**MONTGOMERY COUNTY HISTORIC PRESERVATION COMMISSION**  
**STAFF REPORT**

<b>Address:</b>	7823 Overhill Rd., Bethesda	<b>Meeting Date:</b>	1/5/2022
<b>Resource:</b>	Contributing Resource <b>Greenwich Forest Historic District</b>	<b>Report Date:</b>	12/29/2021
<b>Applicant:</b>	Michael Bern & Rachel Roth Luke Olsen, Architect	<b>Public Notice:</b>	12/22/2021
<b>Review:</b>	HAWP	<b>Tax Credit:</b>	n/a
<b>Permit No.:</b>	967939- Amendment	<b>Staff:</b>	Dan Bruechert
<b>Proposal:</b>	Hardscape, Patio, Modifications to Previously Approved HAWP

# APPLICATION FOR HISTORIC AREA WORK PERMIT

PROPOSED SITE PLAN

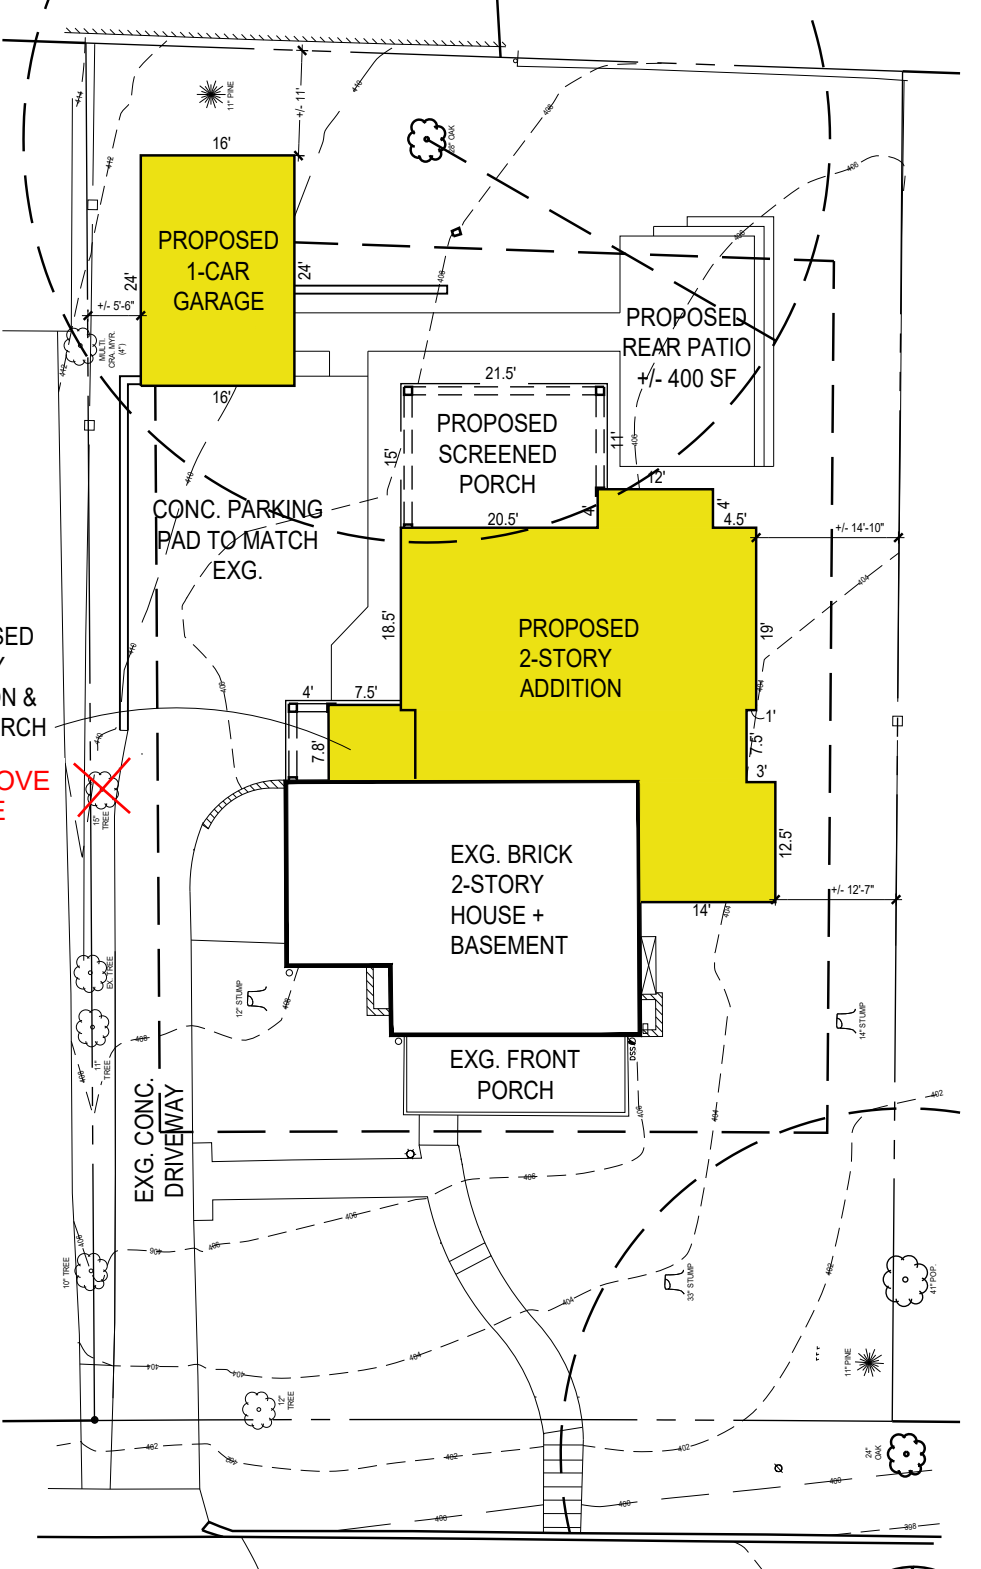
The landscape/hardscape information presented with the October 17, 2021, HAWP was largely illustrative. The applicant returns with full landscape/hardscape plans that include:

- An exposed aggregate driveway with enlarged parking area in the rear;
- Two stone-faced retaining walls;
- 400 ft<sup>2</sup> (four hundred square feet) of bluestone terraces covering two levels with a metal railing;
- A bluestone walkway between the garage and the house; and
- Irregular stepping stones.

Staff finds the materials selected for the proposed hardscaping are generally consistent with the character of the house and surrounding district. The texture of the exposed aggregate driveway and stone retaining walls provide more texture and an irregular finish which is compatible with the park-like setting of the surrounding district. The other materials including the bluestone paving, metal railing, and stepping stones have all been found to be compatible with other properties in the Greenwich Forest Historic District. In this instance, these materials will not be visible from the public right-of-way, so they are entitled to a very lenient level of review.

Staff finds that the 400 ft<sup>2</sup> (four hundred square foot) of the terrace at the rear does not overwhelm the size of the addition and will not be is compatible with the character of the property and surrounding district. Staff finds that after the proposed work is complete, the subject property may not be able to

The attached site plan includes the proposed location of four dry wells and some regrading on the property. This information satisfies condition #2 on the October 17<sup>th</sup> HAWP approval.

**REVISED  
RIGHT SIDE ELEVATION**

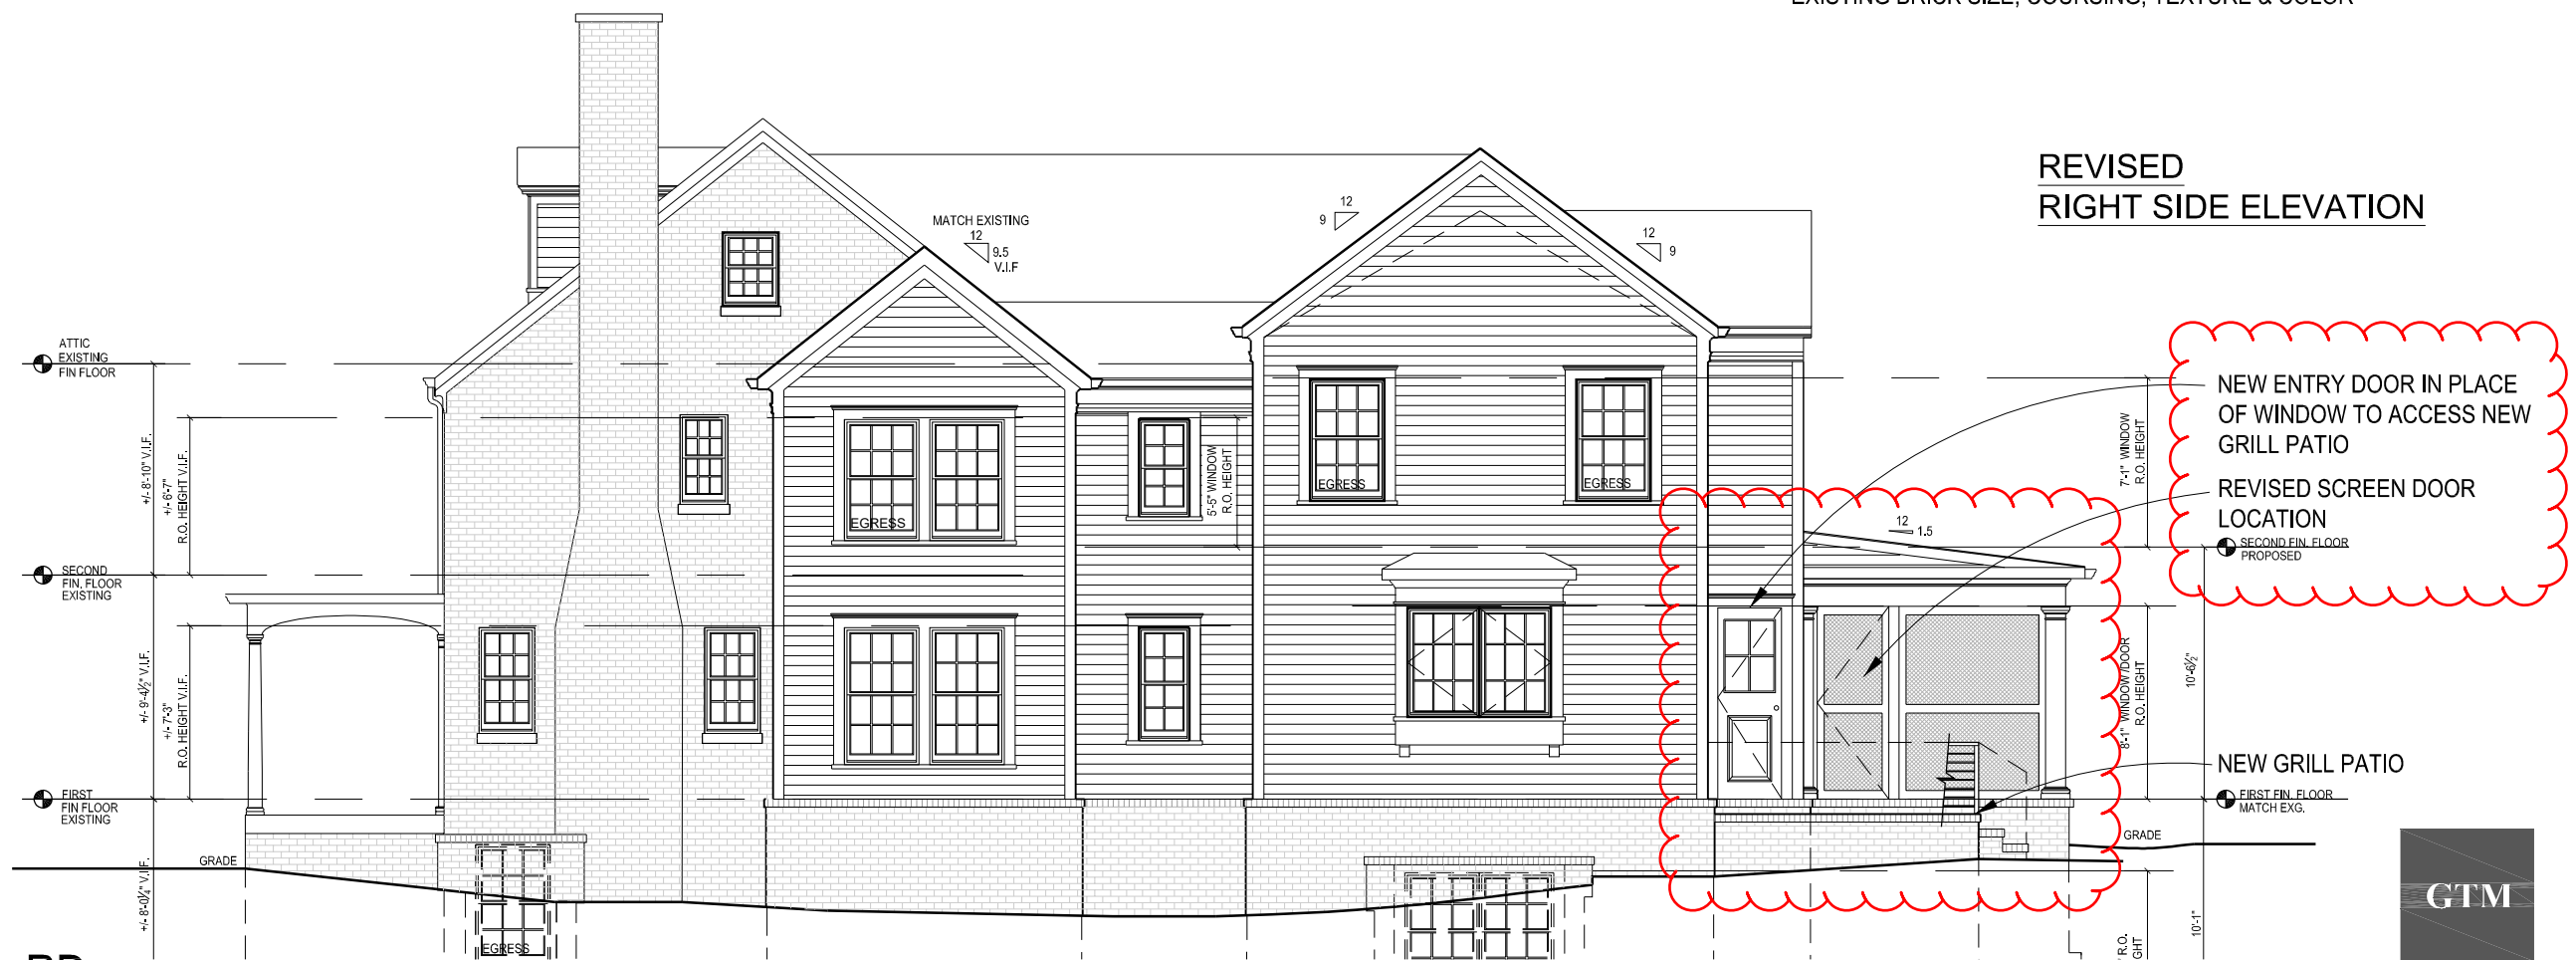
On the south elevation of the approved addition, the applicant proposes removing a window and enlarging the opening to accommodate a door that provides direct access to the proposed rear patio. The proposed door is a half-lite wood door that will not be visible from the right-of-way. As this proposal only alters a previously approved opening with a compatible door, not visible from the public, Staff finds it is entitled to a very lenient review and recommends the HPC approve the new door.

The patio design has been slightly revised from our previous application to include a raised grill patio accessed directly from a new door off of the right side of the breakfast room where we had originally planned for a window. The final dimensions of the patio are 15'-9" x 17'-9" (+/-280 sf) with an additional 7'-4" x 16'-2" grill patio (+/-120 sf). This is consistent with the 400sf patio size we had shown in our original application; we've provided the previously submitted site plan for reference, along with the revised elevations showing the new door and grill patio elevations.
